Contract Description: Main Pumping Station - East Reservoir Addition

CONTRACT CHANGE ORDER NO. 1

OWNER: Village of Orland Park, Illinois
CONTRACTOR: Joseph J. Henderson & Son, Inc.
P.O. Box 9
Gurnee, IL 60031
CONTRACT: East Reservoir Addition

Village of Orland Park, Illinois
East Reservoir Addition

SUPPLEMENTARY
DRAWING
SD03

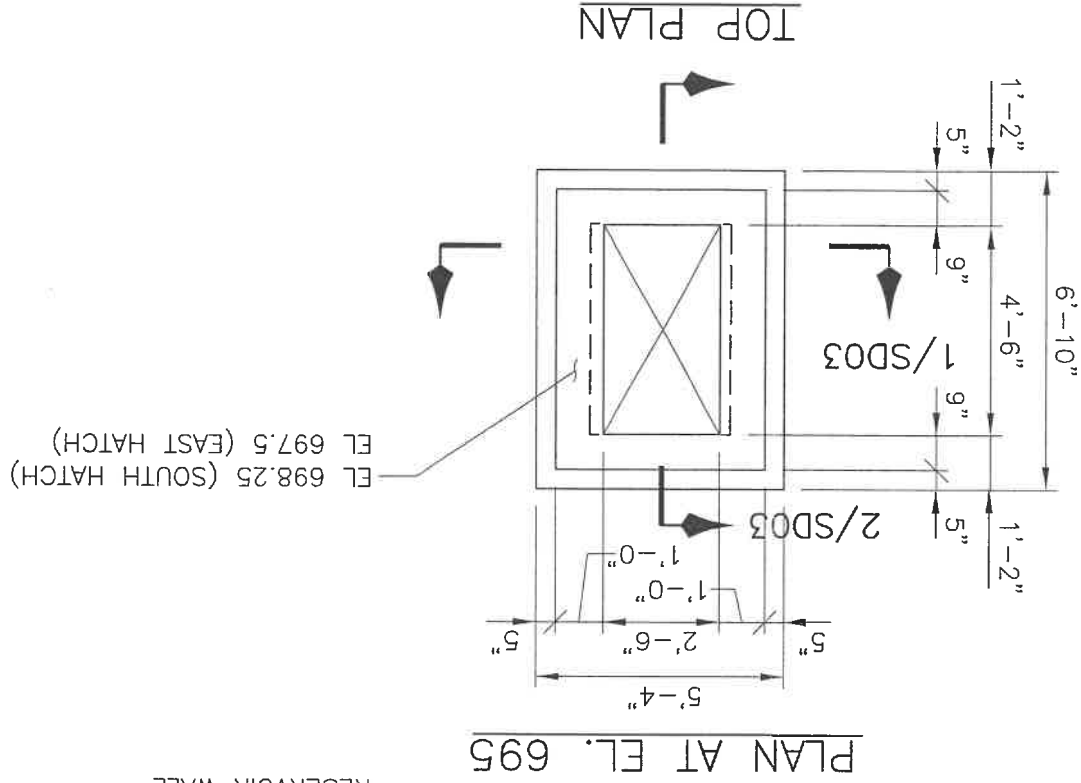
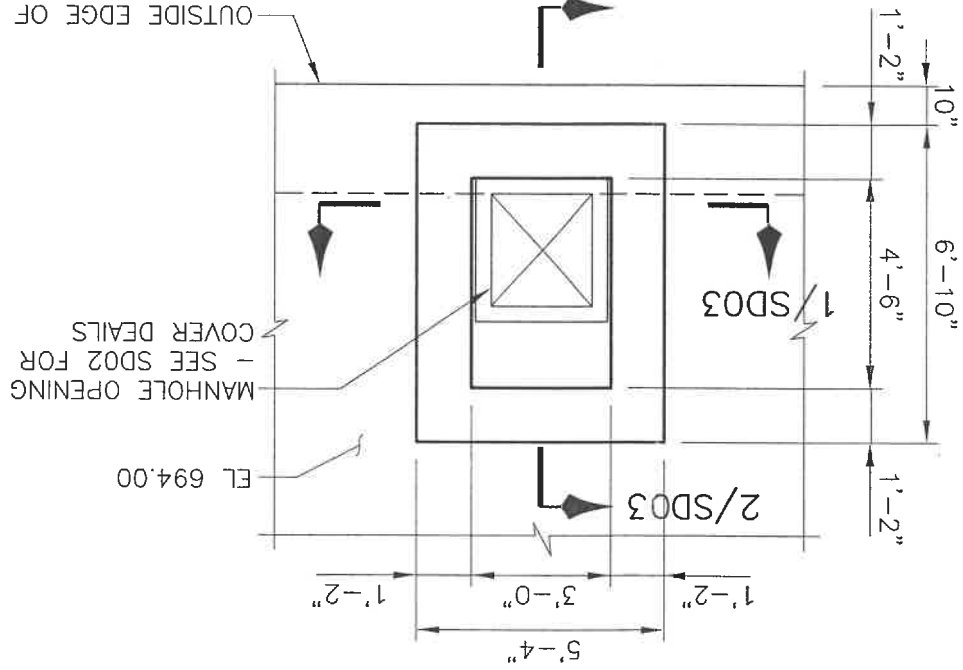
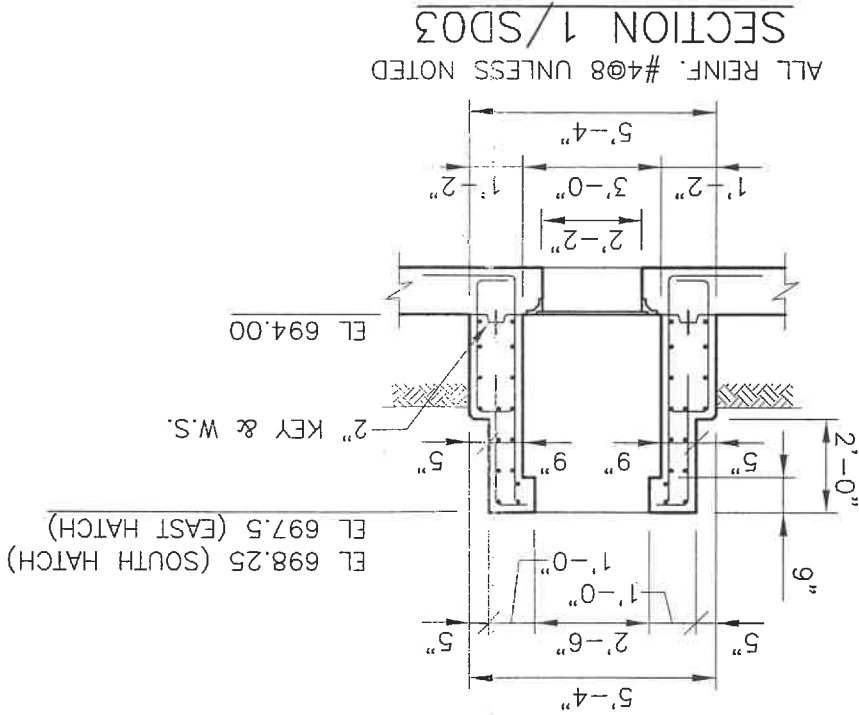
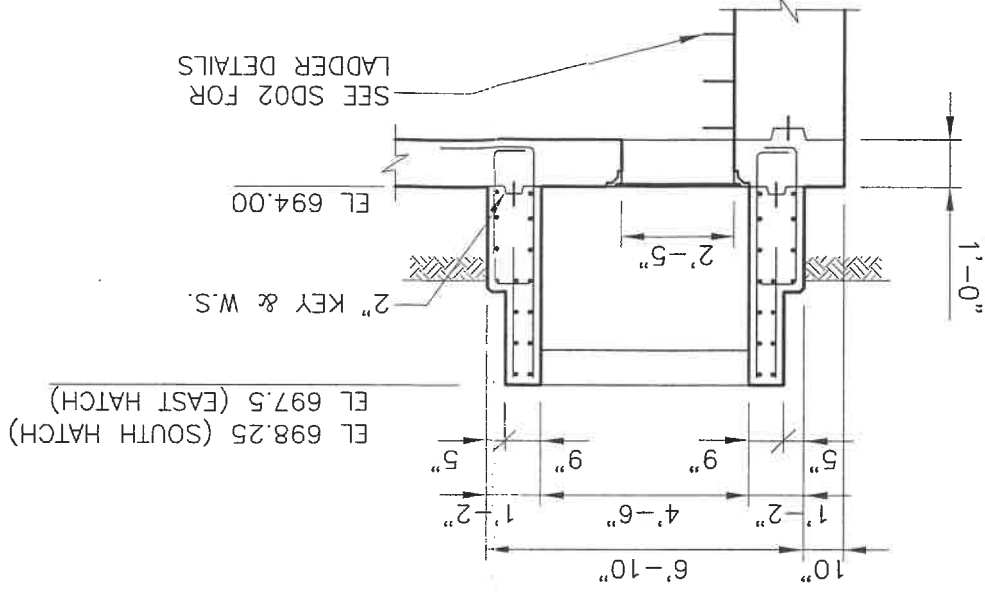
Answer: The short side of the casting is parallel to the outside wall of the reservoir. The actual clear dimensions of the access opening are actually 26 x 29. This is shown in drawing SD03 in the section 2/SD03 where the 29" dimension is perpendicular to the outside wall. Thus, for the casting in slab C, the short side is east-west running and for slab P the short side is north-south running.

Supplementary
Drawing
SD01

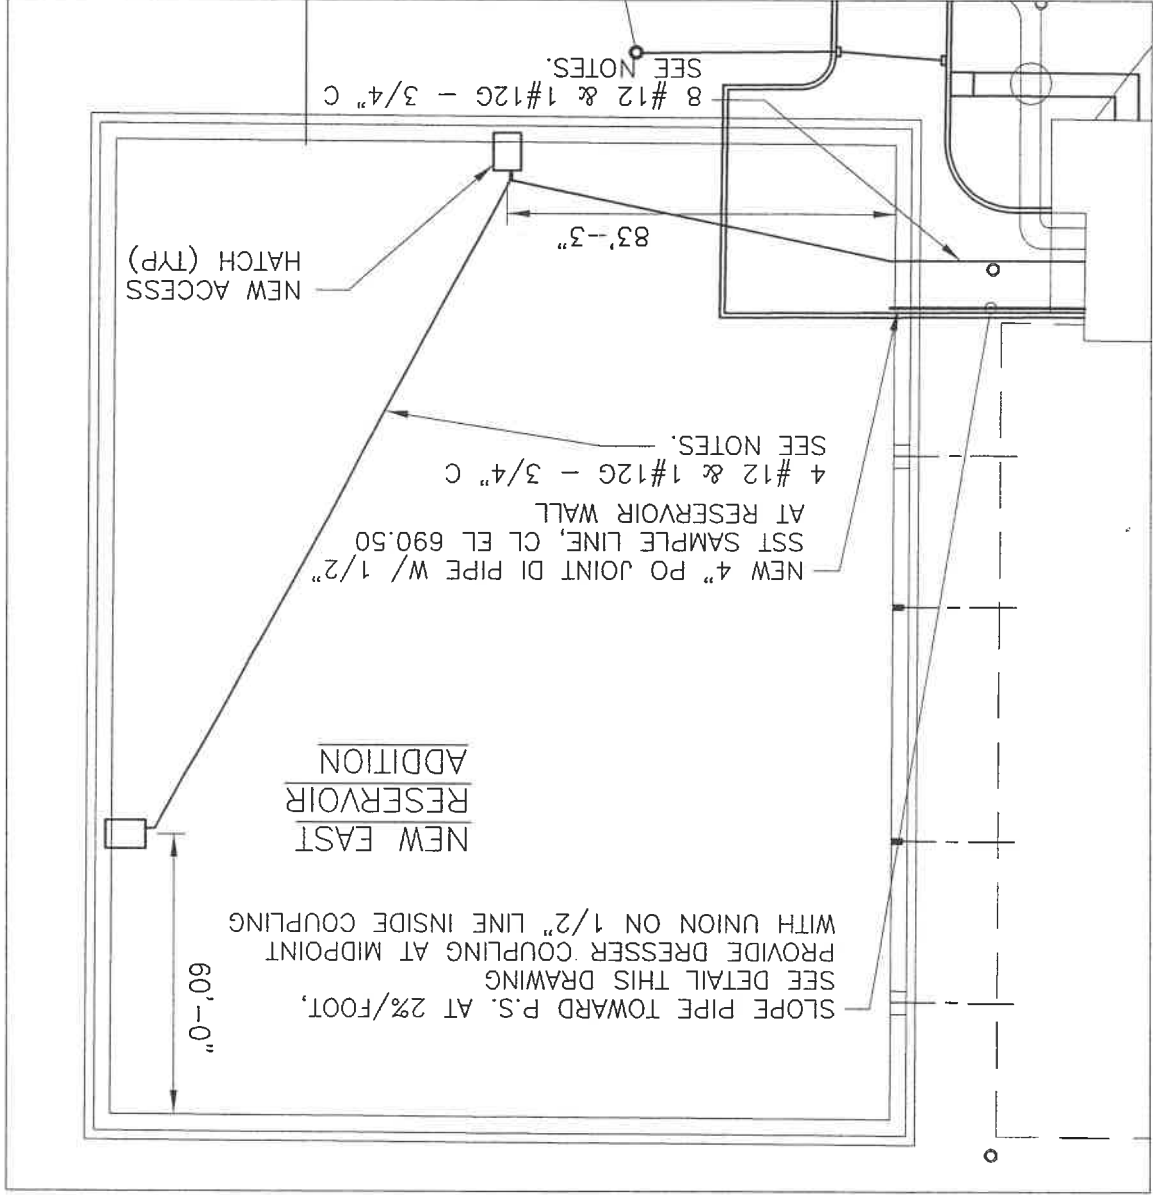
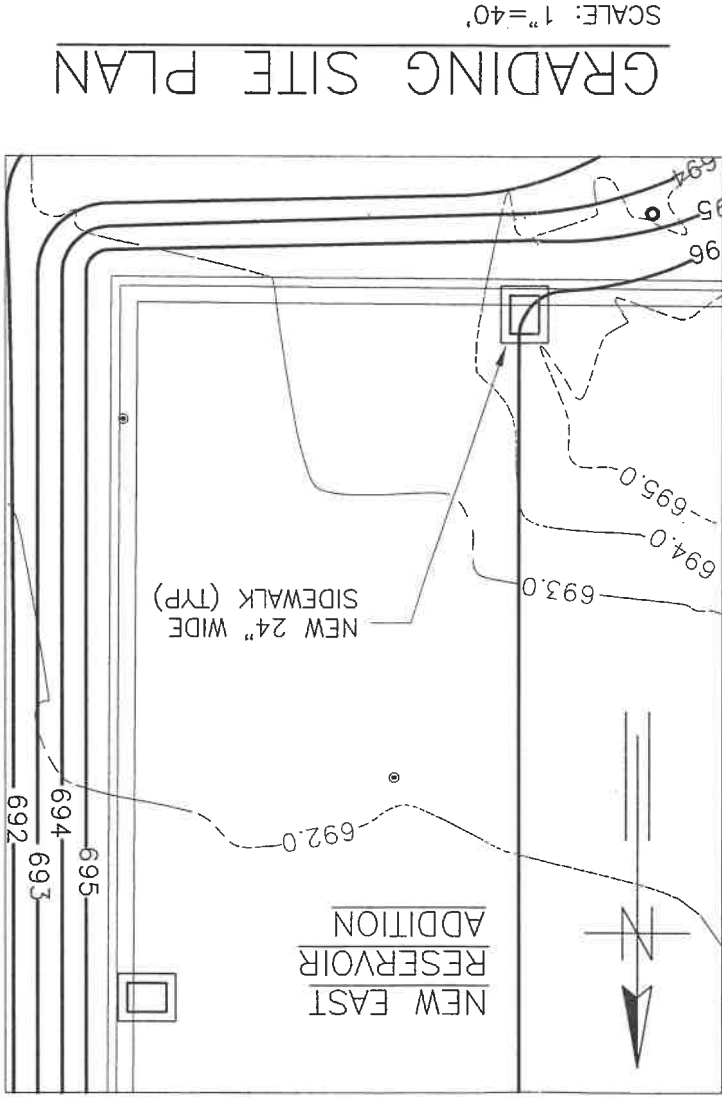
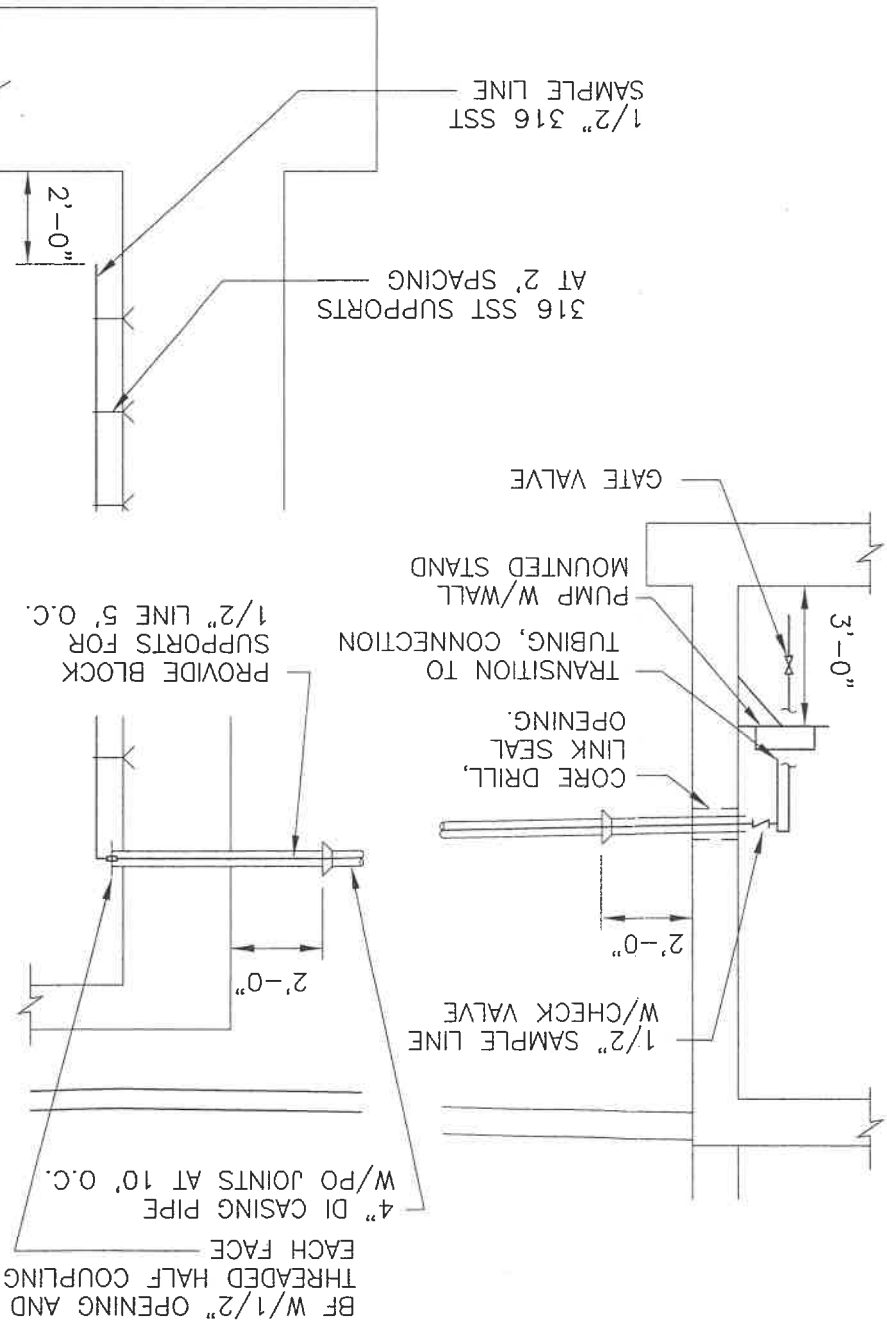
3. In order to obtain a permit to construct and operate, the Illinois Environmental Protection Agency required modifications to the project design including: addition of two access locations to the new East Reservoir Addition with above grade hatches and associated pump shelf, and associated electrical work. The two access hatches in the top slab replaced two of the three concrete slab openings, and were tied into the Main Pump Station Alarm System. The sampling pump was installed inside the Main Pump Station and sample line installed connecting the sampling pump to the new East Reservoir Addition to provide the Owner the ability to sample the water in the new East Reservoir. These modifications were added following acceptance of bids for the project. At the request of the Engineer and the Owner, JJH performed the requested work, which is documented in the Extra Work Order dated July 1, 2009. This work results in an increase in the Contract Price of\$51,944.87

Item No. 3	Joseph J. Henderson & Sons, Inc. Extra Work Order dated 07/01/2009 Supplemental Drawing SD01 "Reservoir Hatches" dated June 2009 Supplemental Drawing SD02 "Hatch Details" dated June 2009 Specification Section 04050 "Masonry Mortar and Grout" Specification Section 04300 "Masonry" Specification Section 07620 "Sheet Metal Flashing and Trim" Specification Section 07724 "Access Hatches" Specification Section 11318 "Sampling Pump Specification Section 15061 "Sampling Piping and Accessories" Email from Beth Vogt dated 04/28/2009

FILE NAME	14601-S2
DWG	S2
SHEET	6 OF 9
DATE	MARCH 2008
REV	0

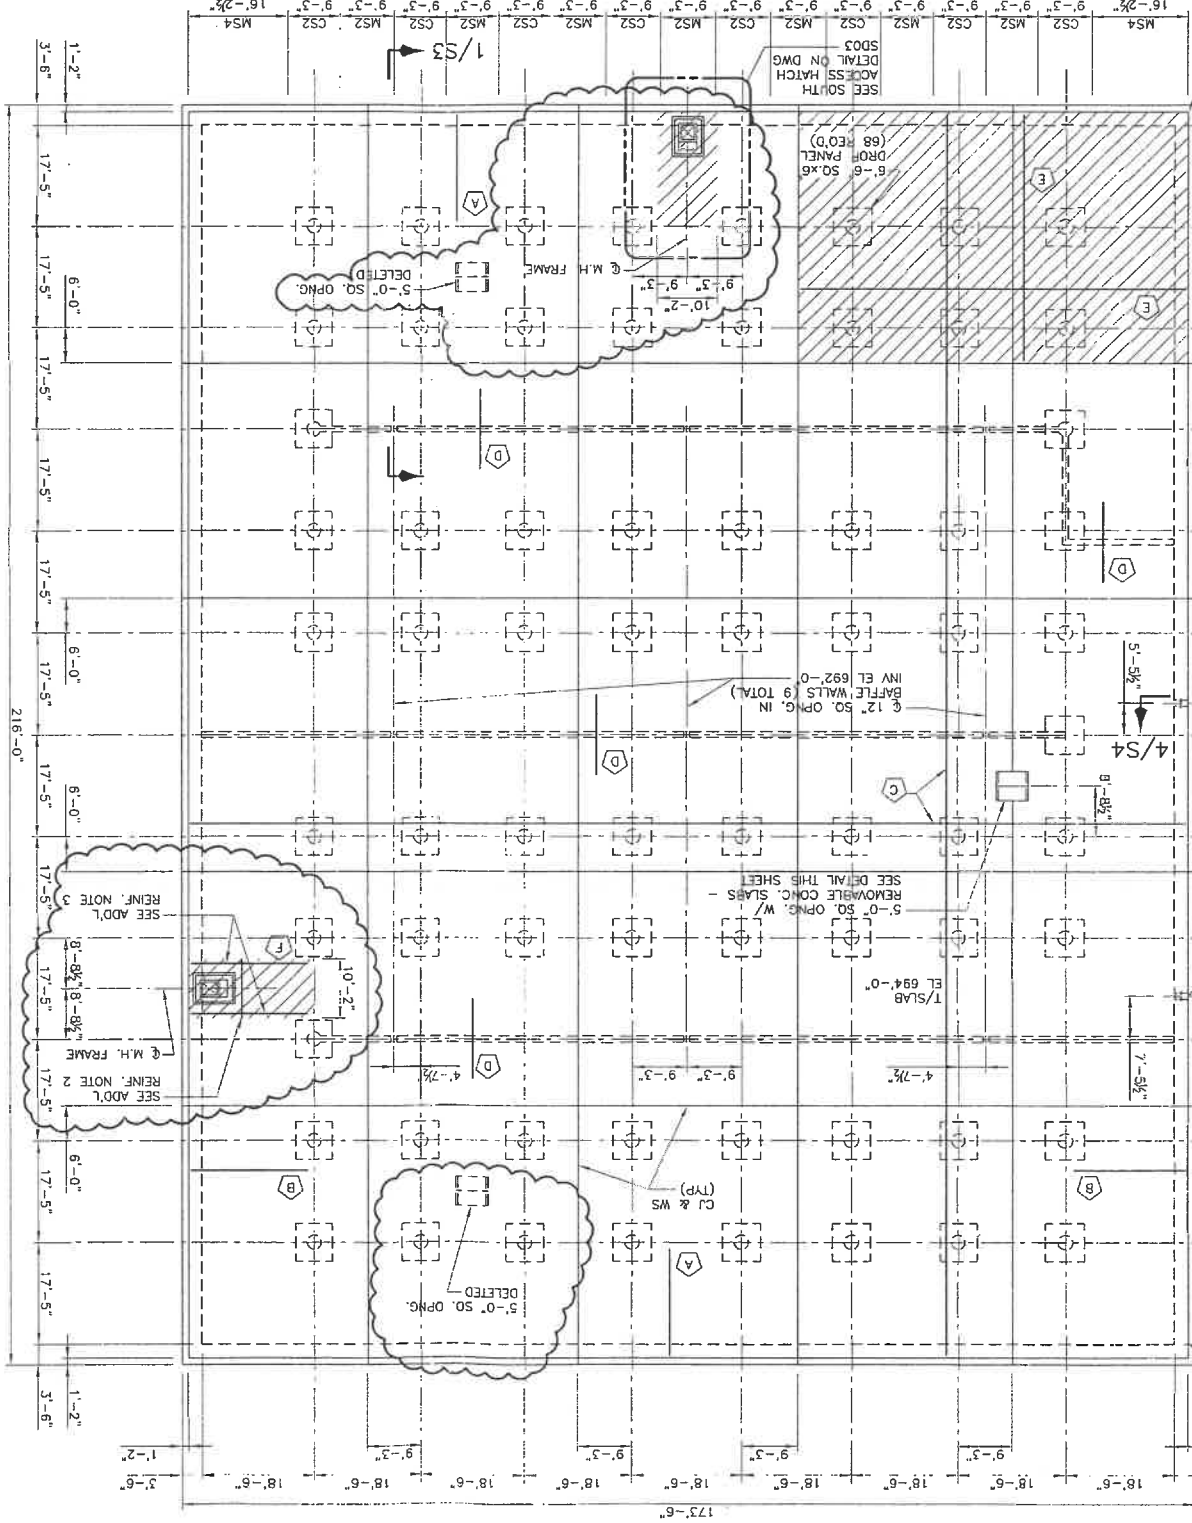
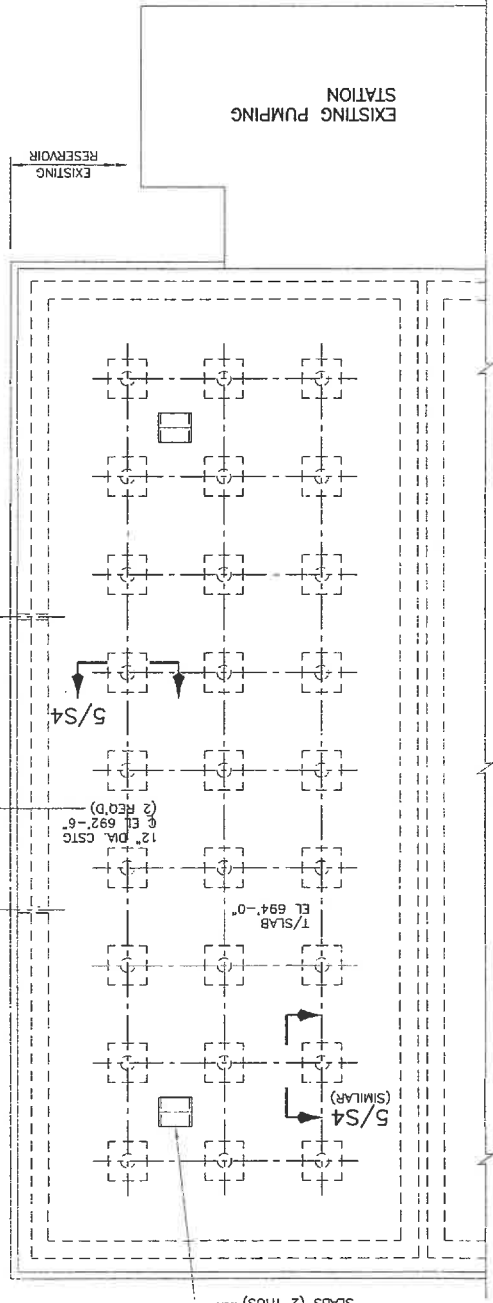
The revisions to Drawing S2 that are bubbled answers the locations questions and SD03 gives the orientation.

Answer: Yes the new casting is in the same location as the original 36" diameter casting was going to be 9'3" from each column line. See revised drawing S2. Yes, the opening, which is actually 26" x 29" clear access needs to clear the wall below.

Answer: The new casting in P is 8'-8.5" from each column line and needs to clear the wall below. See revised drawing S2.

Answer: Yes the two 5'-0" removable slabs in B and V are being eliminated. The only removable slab remaining is in slab O.

I have attached the revised drawings S2, SD03 and the casting cut sheet to this email. Let me know if you have further questions. It is great news that the castings will be coming soon and that the top slabs work is proceeding.
